Service Letter No. 411

SUBJECT: Drain Holes in PA-30 Cowling

MODELS AFFECTED: PA-30 Twin Comanches, Serials 30-1 to 30-85 inclusive

Fuselage Nose Cone

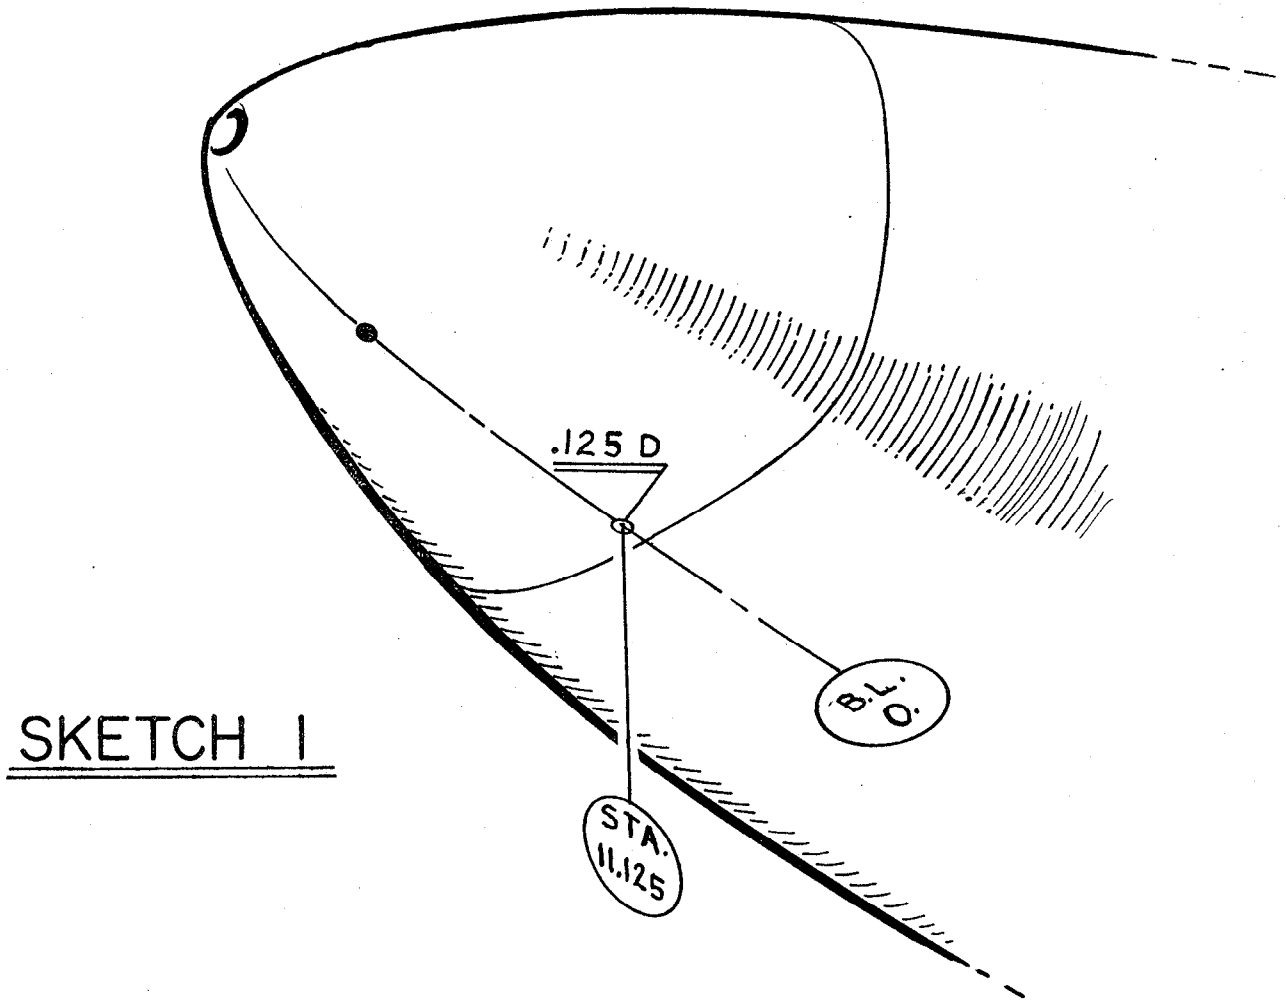
1. Add a .125 drain hole at Station 11.125 and B.L.O. in bottom of fiberglass nose cone, part number 23755-00.
2. Add two .125 drain holes in bottom of each engine bottom cowl, part number 23867-05, right, and part number 23867-06, left, at Stations 32.25 and 33.687, 8-3/4" inboard from the cowl centerline.
3. Add a .125 drain hole in each air filter box assembly, part number 23883-00, per sketch attached to this letter.

Air Filter Box

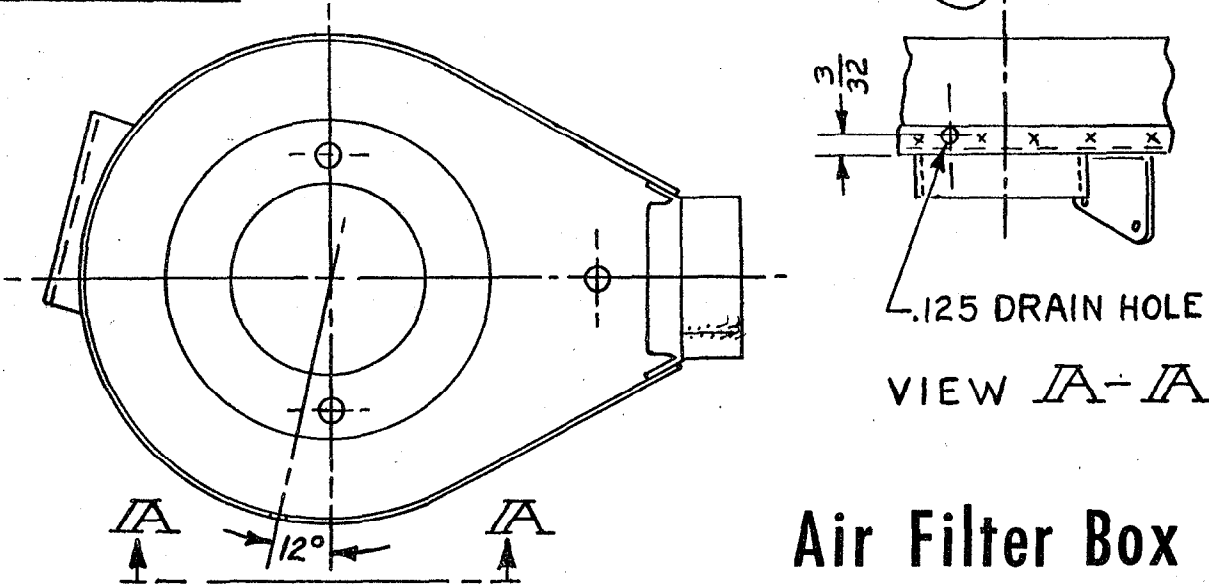
Be sure aluminum chips that result from drilling are completely removed from the air filter boxes.
